# **Improved RAOC and CAOC $F_Q$ Surveillance Technical Specifications**

**WCAP-17661-NP-A**

## NRC FINAL SAFETY EVALUATION

SUBJECT: FINAL SAFETY EVALUATION FOR PRESSURIZED WATER REACTOR  
OWNERS GROUP TOPICAL REPORT WCAP-17661, REV. 1, "IMPROVED  
RAOC AND CAOC FQ SURVEILLANCE TECHNICAL SPECIFICATIONS"  
(CAC NO. MF3348)

**Figure RAI-6.1 Comparison of Predicted Trend in  $F_Q^C(Z)$  or  $F_Q^W(Z)$  as a Function of Cycle Burnup for an Example Plant**

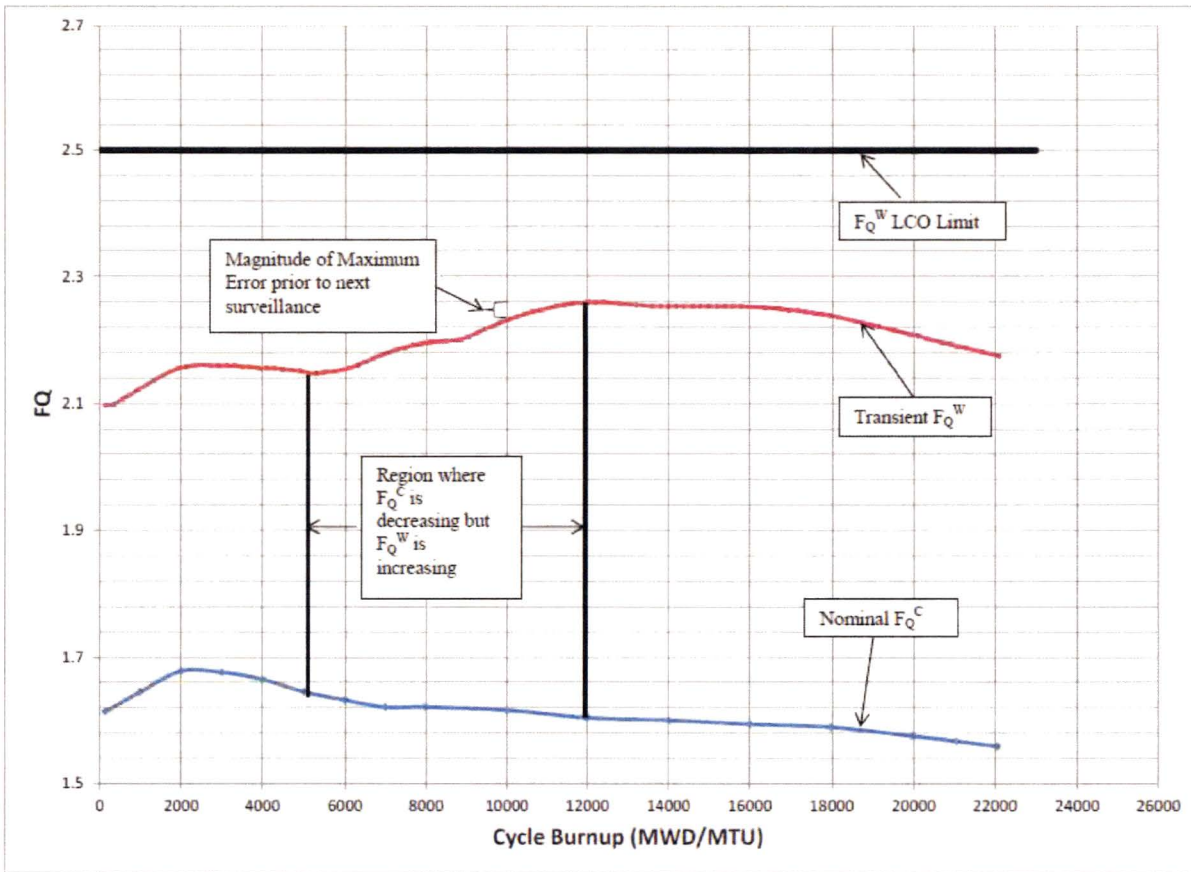
An issue has been identified that the use of measured trends in  $F_Q^C(Z)$  may not always be indicative of the same margin trend in the measured  $F_Q^W(Z)$ , particularly when the axial power distribution of the core is in transition from a cosine type shape to a flattened saddle type shape. Figure RAI-6.1 illustrates an example of such a case by comparing the predicted steady state and maximum transient  $F_Q$  values for an example cycle.

Furthermore, it must be clarified that the initial onset of CIPS will not necessarily result in observing a decreasing trend in either the  $F_Q^C(Z)$  or  $F_Q^W(Z)$  margin. The preferential accumulation of boron-containing crud in high power assemblies will tend to decrease the radial peaking ( $F_{xy}(Z)$ ) in the affected elevations of the highest power assemblies. If the nominal predicted AFD is slightly positive, the onset of CIPS may result in the AFD being closer to zero or slightly negative. Both of these factors could result in an increasing trend in margin for  $F_Q^C(Z)$ , initially. The trend in  $F_Q^W(Z)$  is driven largely by the  $T(Z)$  or  $W(Z)$  surveillance factors, which, as noted in Section 4.5 of WCAP-17661-P, will not include the effects of CIPS if it occurs. Thus, the observation of past trends in margin for either  $F_Q^C(Z)$  or  $F_Q^W(Z)$  is not very useful in identifying the onset of CIPS. Only in the later stages of a relatively severe CIPS event can it be stated with high confidence that the  $F_Q^C(Z)$  margin will be decreasing with burnup.
